Australian Air Publication 721.79

ROYAL AUSTRALIAN AIR FORCE

VAMPIRE MODIFICATIONS

(Nos 1 to 100)

Drawing No. A-1/1367 SHT 1.
Drg B size
Limits unless stated
Decimals ± .010"
Fractions ± 1/32"
Angles ± 1°
Surface Finish
Australian Standard
Eng. Drg. Practise A.S. C21.
Material
Spec.
Treatment
Finish
Scale
Drawn
Traced
Approved
Checked

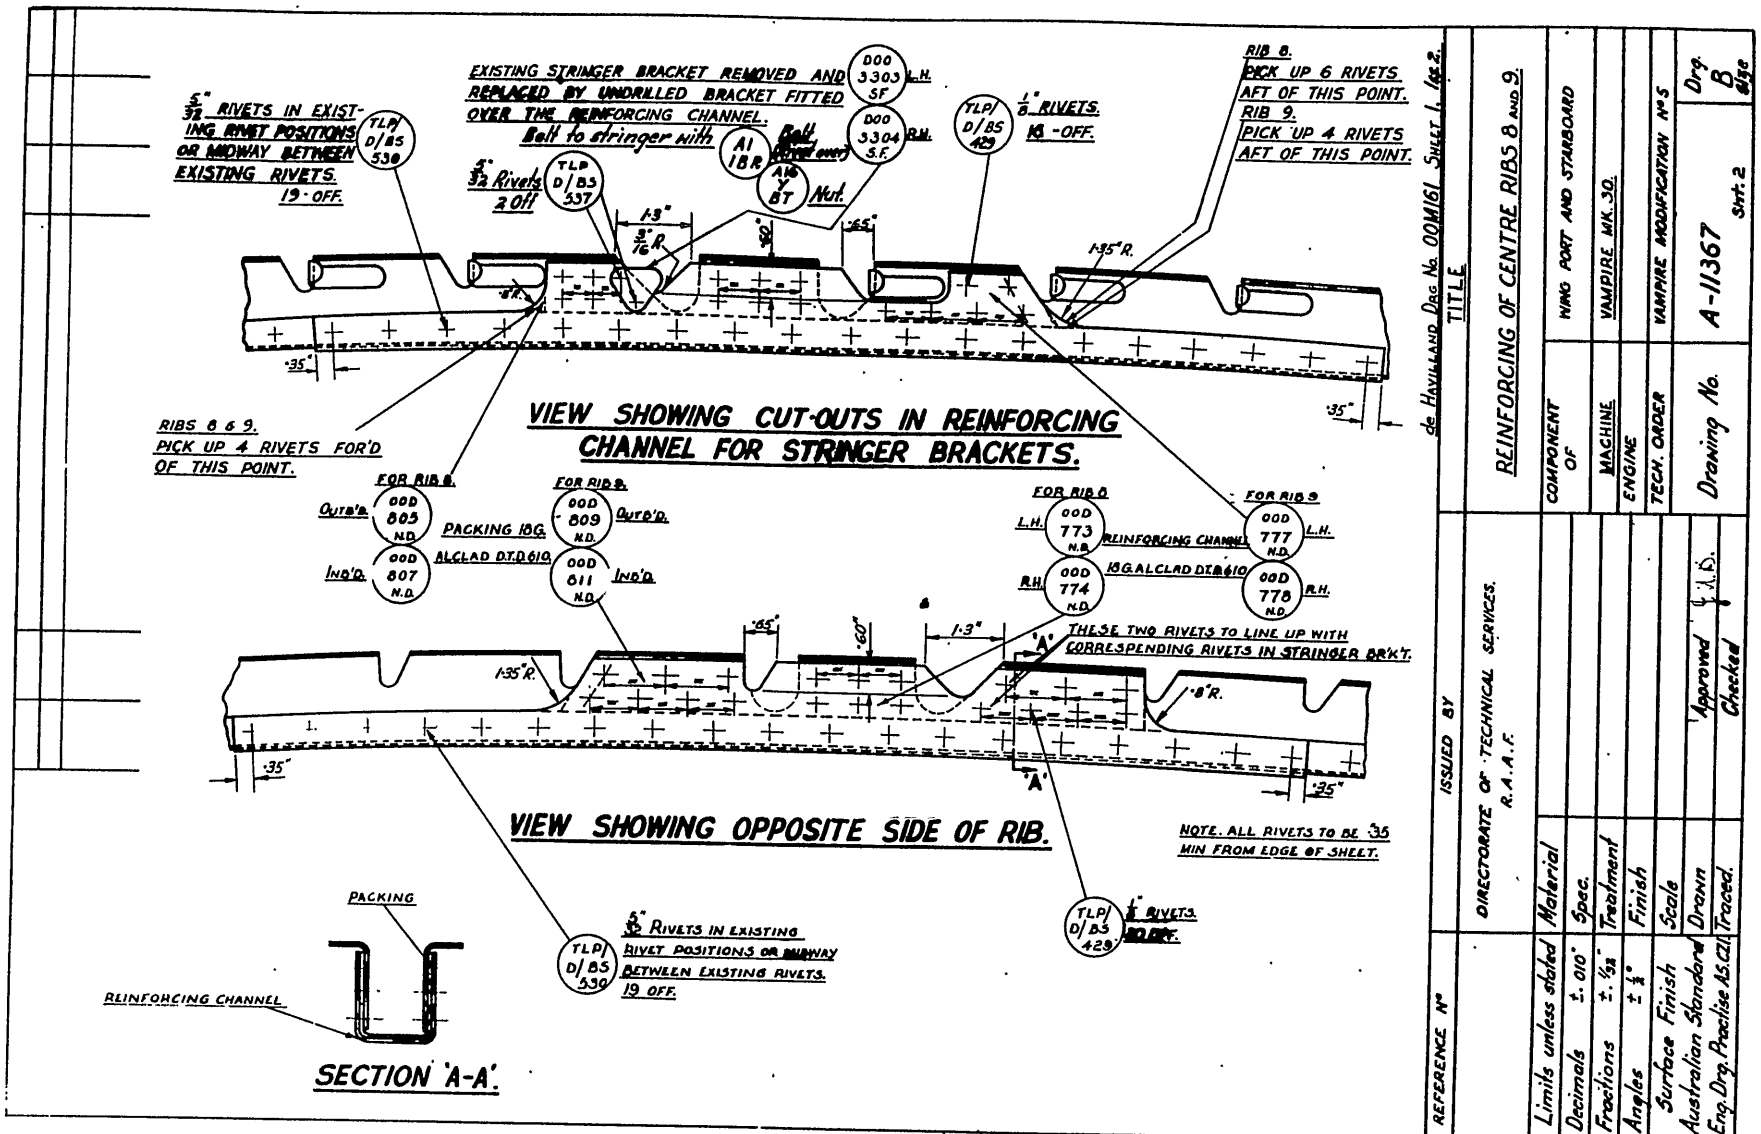
7. Modify ribs 6, 8 and 9 as shown on Drawing No. A.11367, Sheets 1 and 2 attached.

5" 32 RIVETS IN EXISTING RIVET POSITIONS OR MIDWAY BETWEEN EXISTING RIVETS. 19 OFF.
TLP/D/BS 530
EXISTING STRINGER BRACKET REMOVED AND REPLACED BY UNDRILLED BRACKET FITTED OVER THE REINFORCING CHANNEL. Bolt to stringer with
D00 3303 S.F. L.H.
D00 3304 S.F. R.H.
A1 1BR.
A1B Y BT Nut.
Ball
TLP/D/BS 429
1" 8 RIVETS. 18 OFF.
RIB 8. PICK UP 6 RIVETS AFT OF THIS POINT. RIB 9. PICK UP 4 RIVETS AFT OF THIS POINT.
5" 32 Rivets 2 Off
TLP D/BS 537
1·3"
3" 16 R.
·65"
·60"
·8"R.
1·35"R.
·35"
RIBS 8 & 9. PICK UP 4 RIVETS FOR'D OF THIS POINT.
VIEW SHOWING CUT-OUTS IN REINFORCING CHANNEL FOR STRINGER BRACKETS.
FOR RIB 8.
FOR RIB 9.
OUTB'D.
IND'D.
D00 805 N.D.
D00 807 N.D.
PACKING 18G. ALCLAD D.T.D.610.
D00 809 N.D.
D00 811 N.D.
FOR RIB 8
FOR RIB 9
L.H.
R.H.
D00 773 N.D.
D00 774 N.D.
REINFORCING CHANNEL 18G. ALCLAD DTD610
D00 777 N.D.
D00 778 N.D.
THESE TWO RIVETS TO LINE UP WITH CORRESPONDING RIVETS IN STRINGER BR'KT.
'A'
VIEW SHOWING OPPOSITE SIDE OF RIB.

NOTE. ALL RIVETS TO BE ·35 MIN FROM EDGE OF SHEET.
PACKING
REINFORCING CHANNEL
TLP/D/BS 539
5" 32 RIVETS IN EXISTING RIVET POSITIONS OR MIDWAY BETWEEN EXISTING RIVETS. 19 OFF.
TLP/D/BS 429
SECTION 'A-A'.
de HAVILLAND DRG No. 00M161 SHEET 1. ISS 2.
ISSUED BY
DIRECTORATE OF TECHNICAL SERVICES. R.A.A.F.
REFERENCE N°
TITLE
REINFORCING OF CENTRE RIBS 8 AND 9.
COMPONENT OF
WING PORT AND STARBOARD
MACHINE
VAMPIRE MK. 30.
ENGINE
TECH. ORDER
VAMPIRE MODIFICATION N°S
Drg. B size

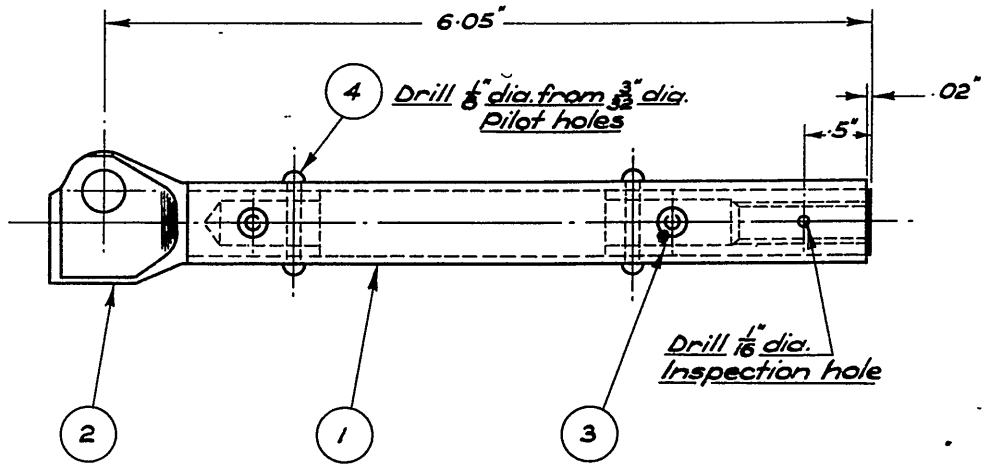
(j) Secure the end fittings (G00127A and G00249) to the tube (item 1) by using four (4) new rivets (item 8) identifying the end into which each fitting is to be tapered by the relative position of the rivet holes in the tube (see drawing A.12049).

D.H. DRG. No 00M/SG

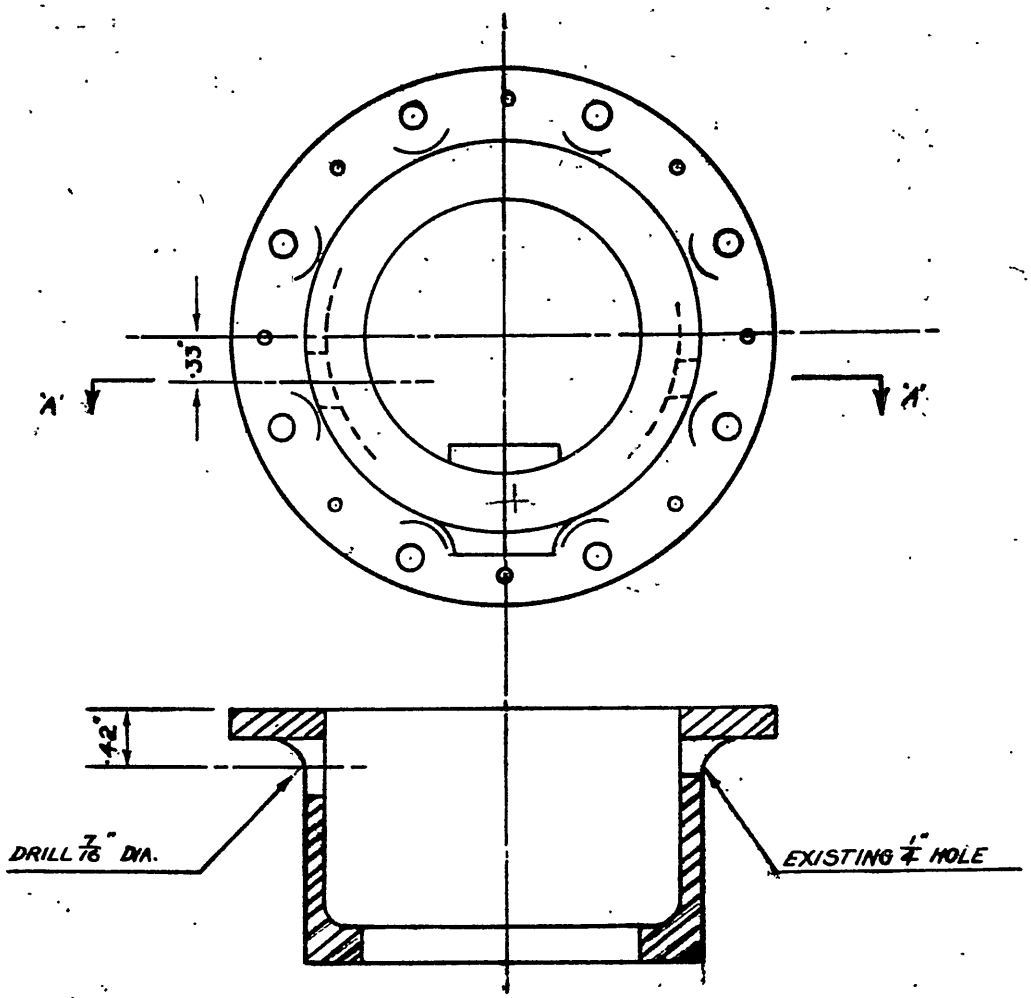
16. Refer to drawing A11736 and drill 7/16" dia. hole in opposite side of casting to existing 1/4" dia. hole.

D.H. DRG. No. 00M162.

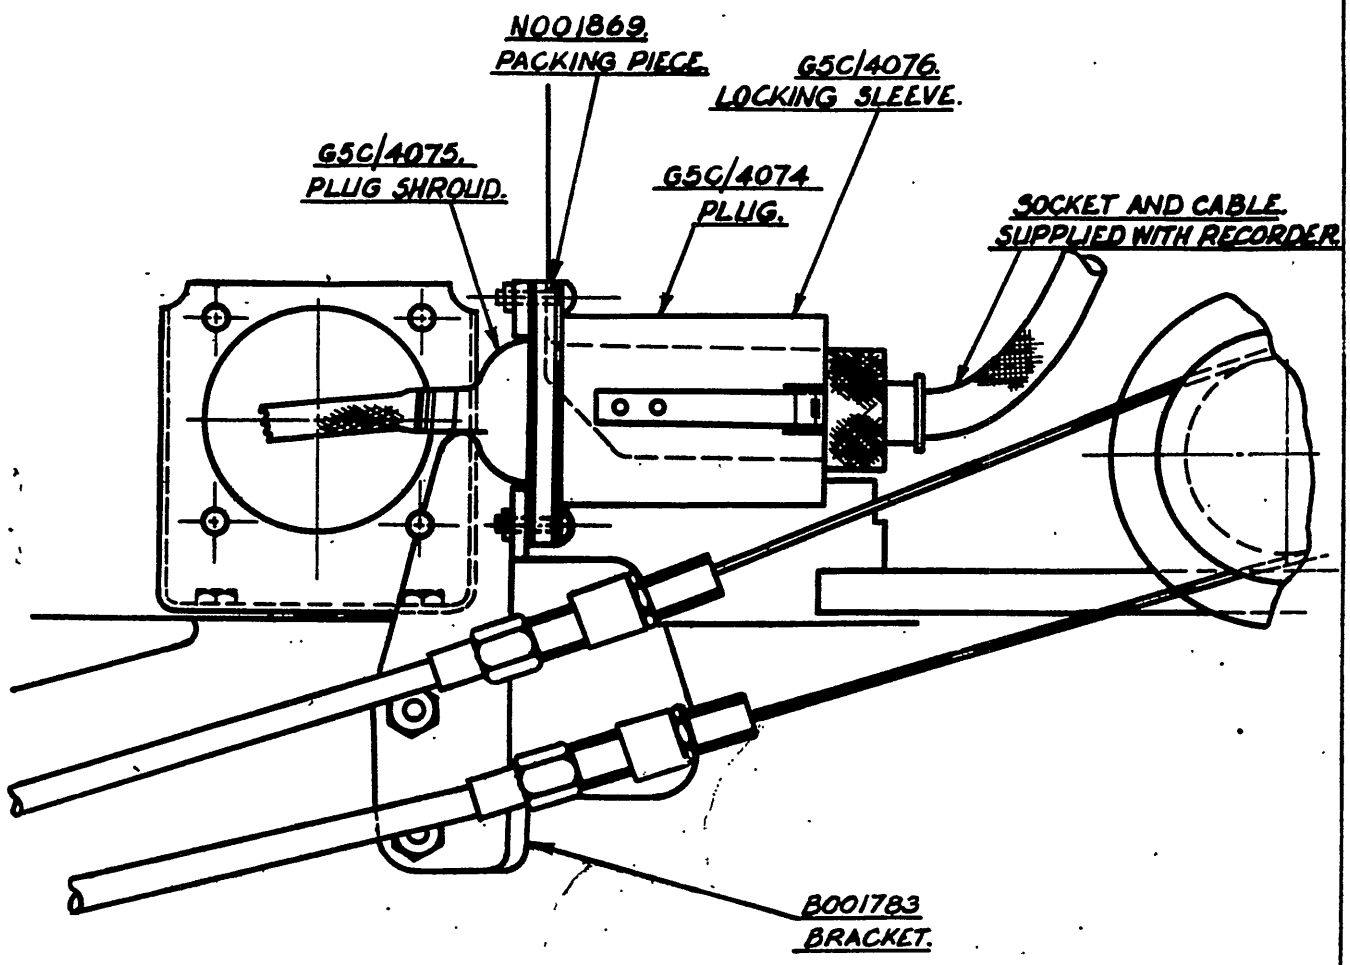
(vii) Complete plug assembly with locking sleeve, item 3, and fix to bracket using two (2) off bolts, item 6, and two (2) off nuts retained from operation (iii). Refer Drawing A12324.

VIEW ON L.H. SIDE OF GYRO GUNSIGHT.
SHOWING NEW OUTLET PLUG INSTALLED.

De Havilland Drawing OCM189.

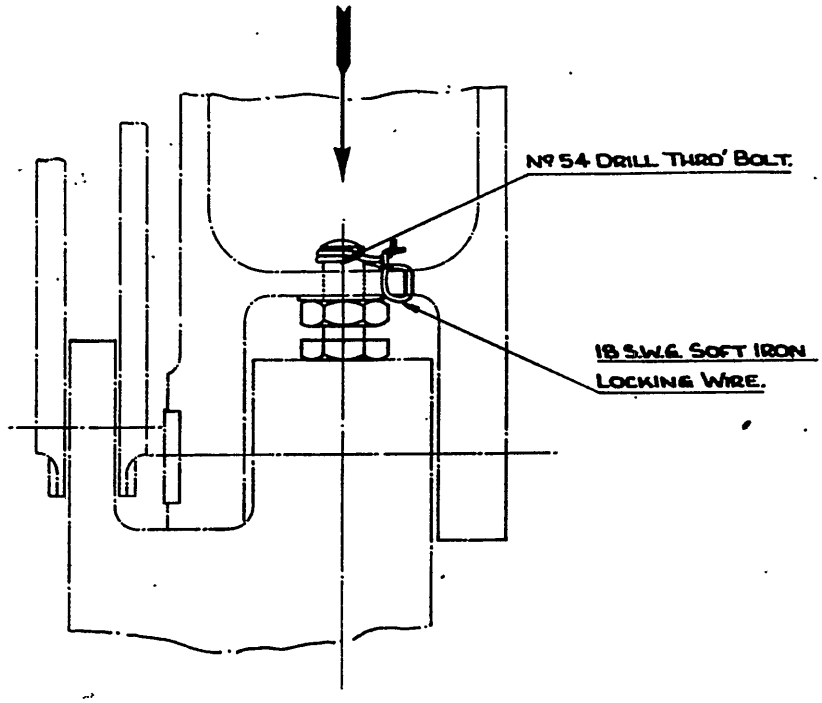
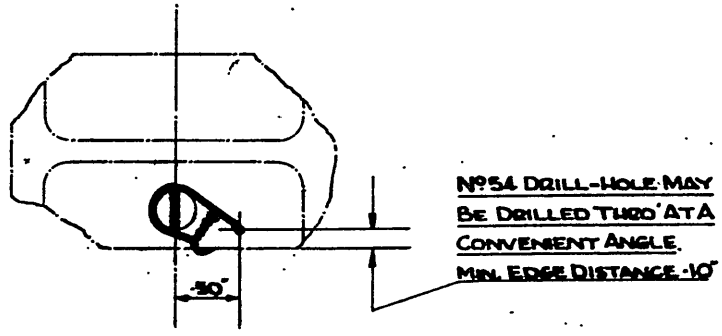
(e) Drill the bottom flange of the upper link (Item D, figure 23) and the rail of the bolt as shown on drawing.

VIEW LOOKING INBOARD ON PORT RADIUS ROD.

SCRAP VIEW ON ARROW.

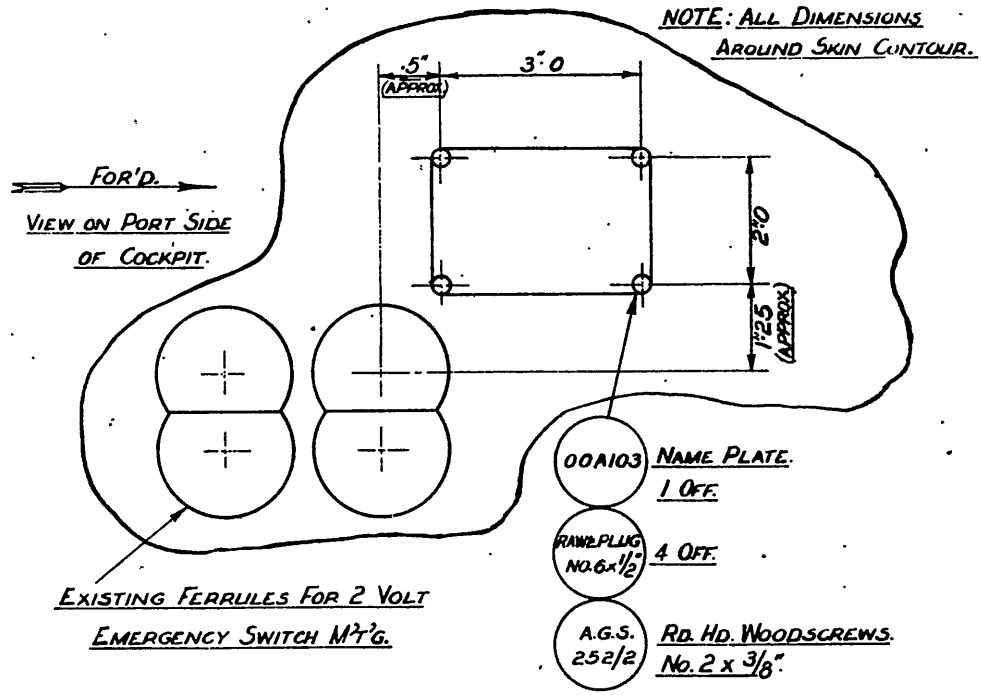
(a) Drill four (4) No. 28 holes for rawl plugs at the position shown on the drawing A.11944, using a stop on the drill to ensure the holes do not damage or touch the outer ply.

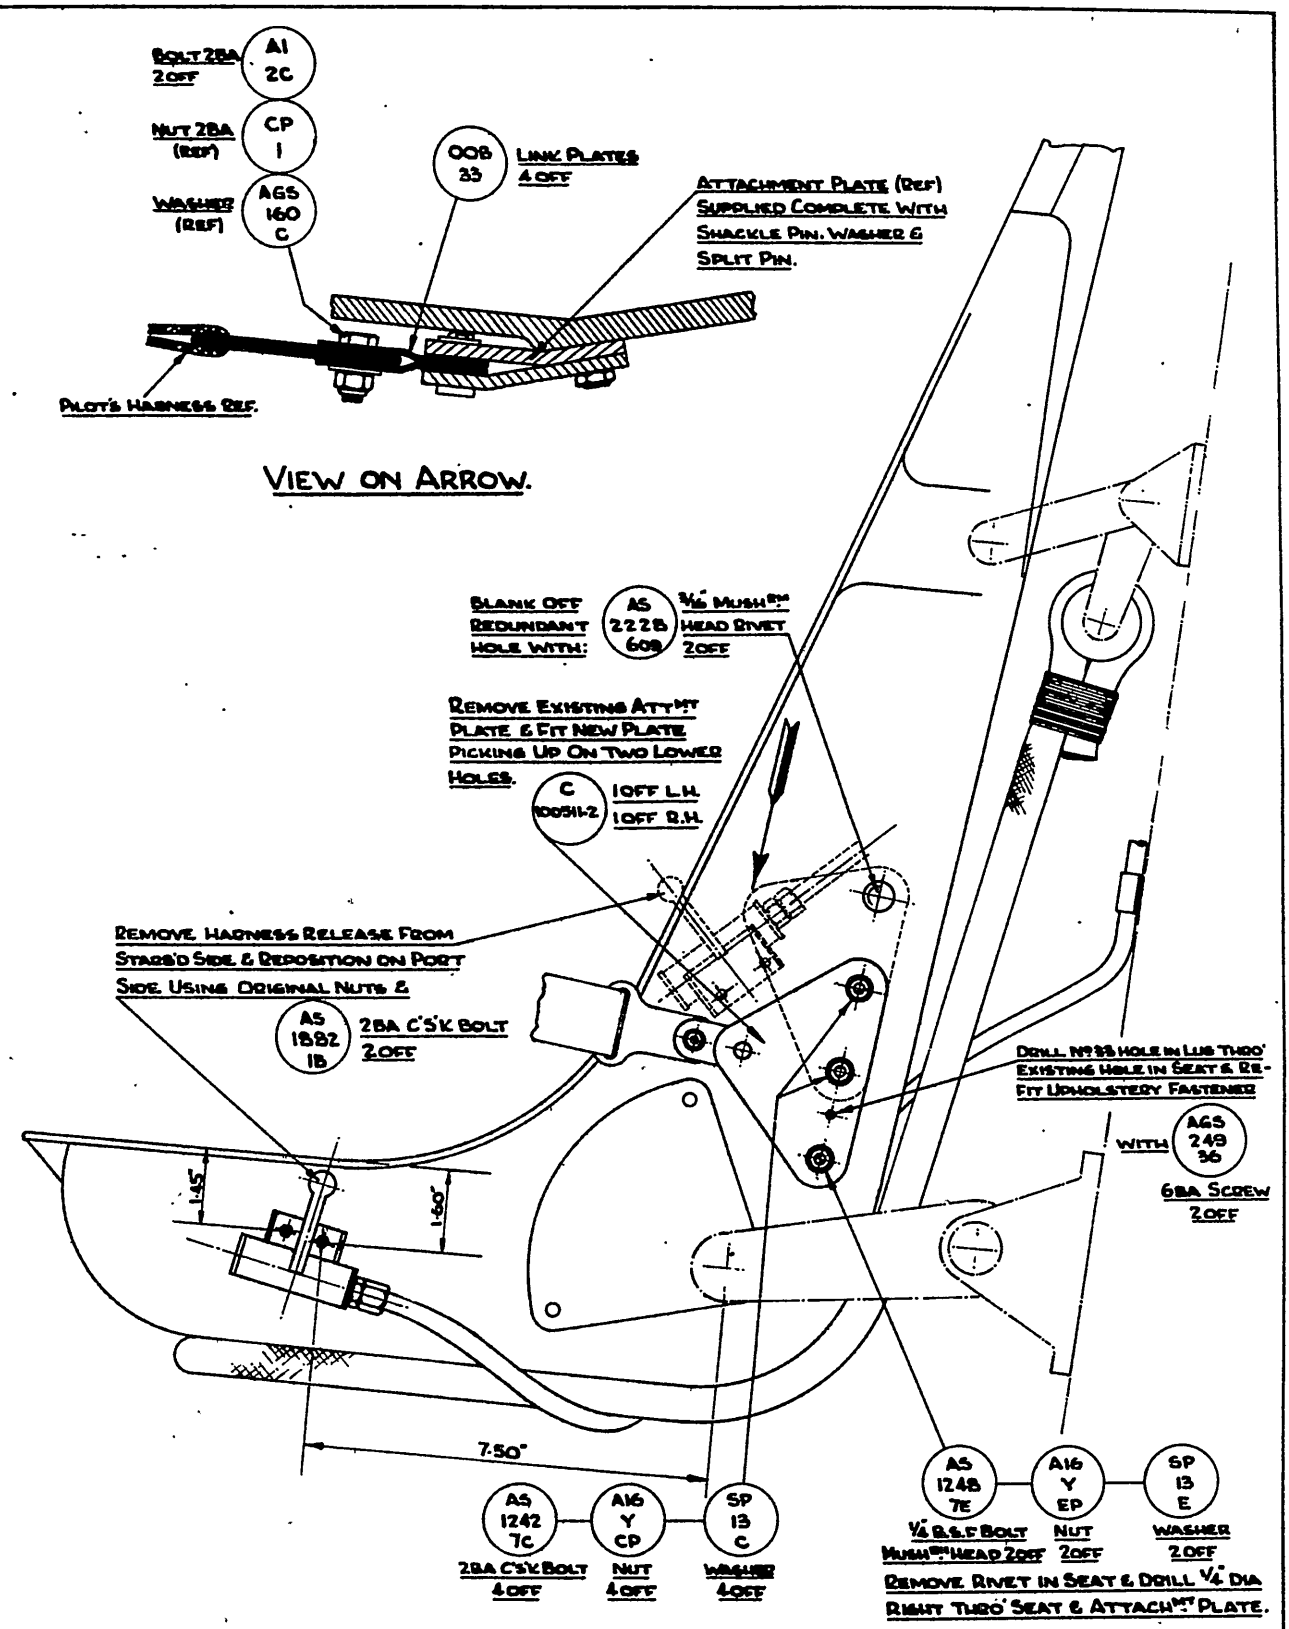
13. Refer to drawing A11773 and position new attachment plates (items 1 and 2) so that the two holes on plate pick up with the two bottom holes of the group of three previously used to secure (item 14) removed at Op.10. Secure using bolts Item 5 nuts (item 10) and washers (item 11).

17. Locate and drill two No.26 holes in port side of seat for new position of harness release (refer drawing A11773). Countersink inside face to suit bolts (item 6).

18. Assemble link plates (item 3) to harness using washers and nuts retained at op.8 and bolts (item 7) (refer drawing A11773).

DE HAVILLAND DRAWING OOM169.

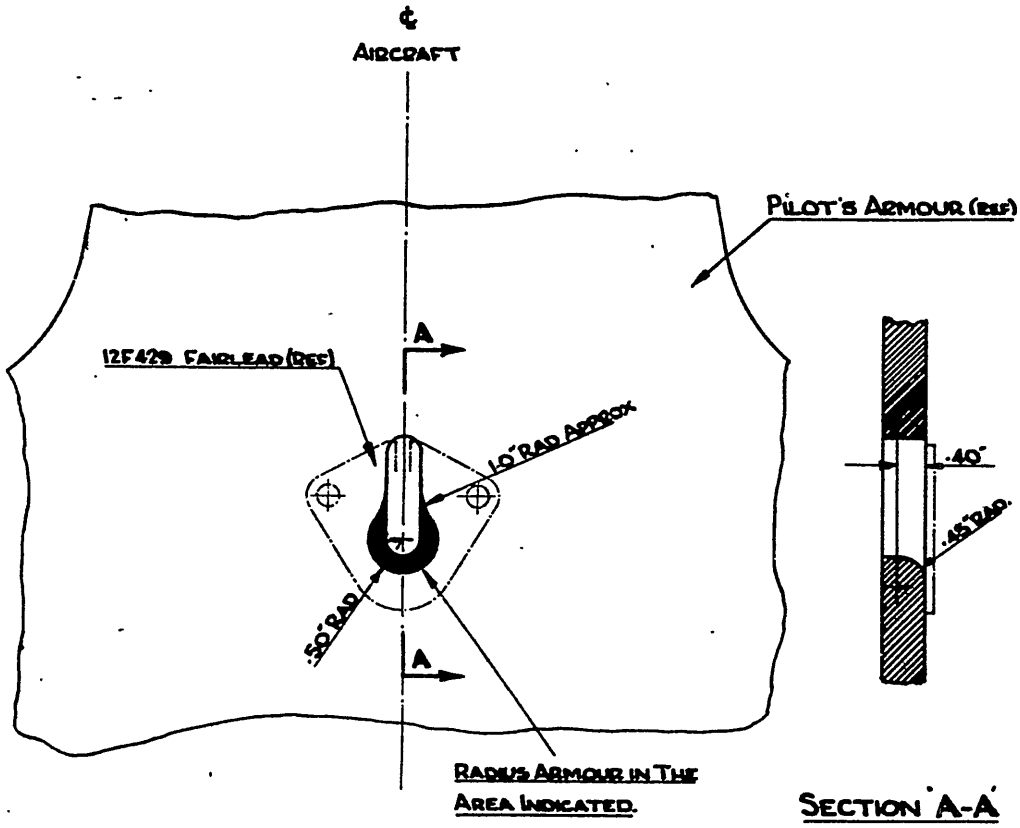
8. Using a portable grinder or a file radius armour plate in accordance with drawing A11770.

DE HAVILLAND DRG. Nº 00M 198

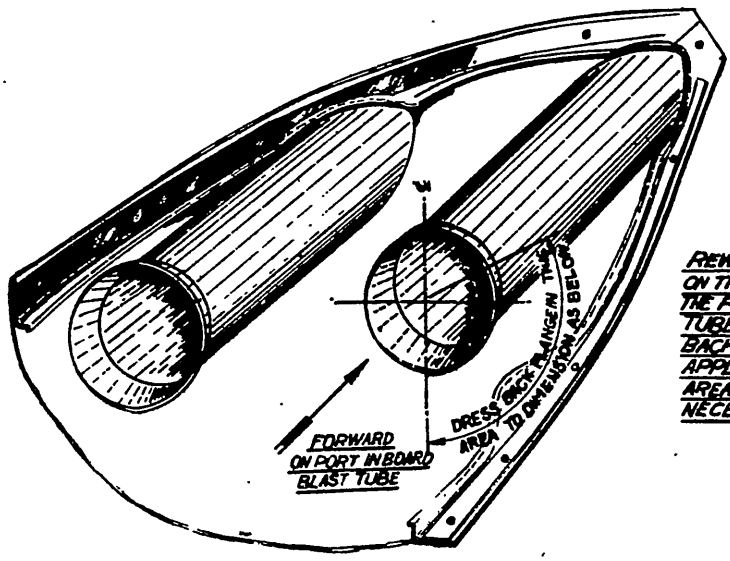
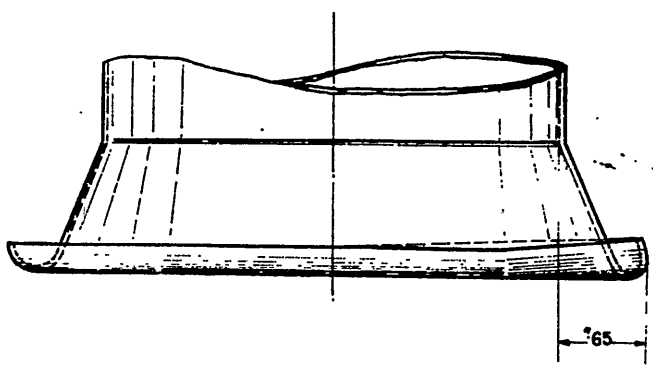
REWORK THE FLANGE ON THE FLARED END OF THE PORT INNER BLAST TUBE BY DRESSING BACK AS SHOWN APPLYING HEAT TO THE AREA OF REWORK IF NECESSARY
